TECHNICAL NOTE

Job Name: Bristol Airport Appeal
Job No: 48889
Note No: TN32
Date: 7.06.2021
Prepared By: Erica Deane / Scott Witchalls
Subject: Airport Gyratory

Airport Gyratory Assessment

Figure 1.1 – Existing/ Proposed Layout Flow Comparison

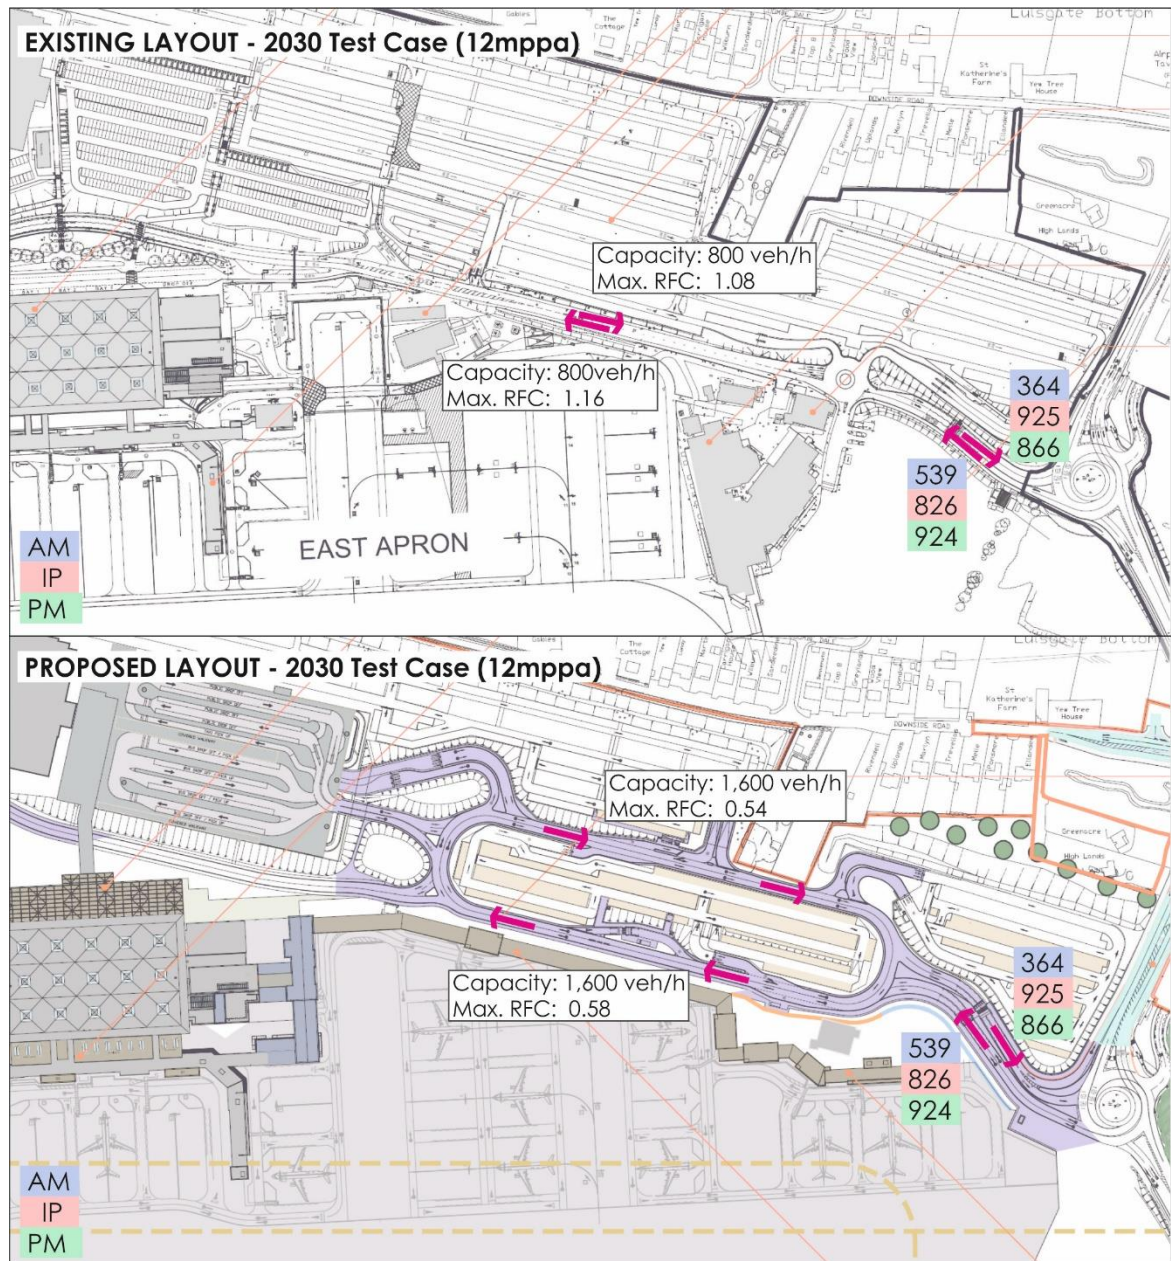
- 1.1. This note has been prepared in response to a request from NSC for additional information regarding the proposed airport gyratory improvements associated with the application for the expansion of Bristol Airport to 12mppa.
- 1.2. This note builds upon the statement made by NSC in the Committee Report for the development (dated 10th February 2020), which stated (p.135) that:

- 1.14. Based on the **Qc** value of 800 veh/h, a maximum Ratio of Flow to Capacity (RFC(**Qc**)) of the existing and proposed internal layout of the airport has been calculated at the point where the highest levels of traffic are expected. Traffic flows are expected to disperse to the west of the first on site junction, as cars enter car parks along the road i.e. car hire, short stay, MSCP. The results of this assessment are illustrated in **Figure 1.1** below, showing worst case RFC(**Qc**) values of 1.16 for the existing layout and 0.58 for the proposed gyratory.

- 1.16. This assessment has demonstrated that the proposed gyratory will provide additional capacity compared with the existing layout and that it is likely to operate substantially within its maximum capacity, even based on conservative assumptions.
